HARTING Product Change Notification

Business Unit: Electric
Product range: Han / Han-Modular
Author: Heinz-Guenter Spreen
Title: Han(R) TC70 Contact 2,5-16mm²

PCN/23/012/C+N
Date: 2023-07-25

Exemplary image of old contact

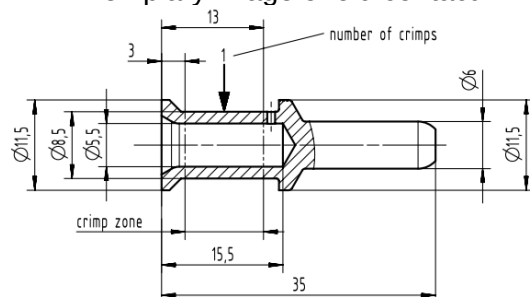
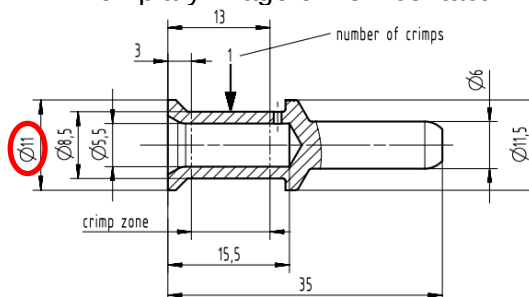
The outer diameter of the Han® TC70 contacts 2.5 – 16 mm² will be reduced from 11.5 mm to 11.0 mm on the termination side only.

The outer diameter 11.5 mm on the mating side and all other dimensions remain the same.
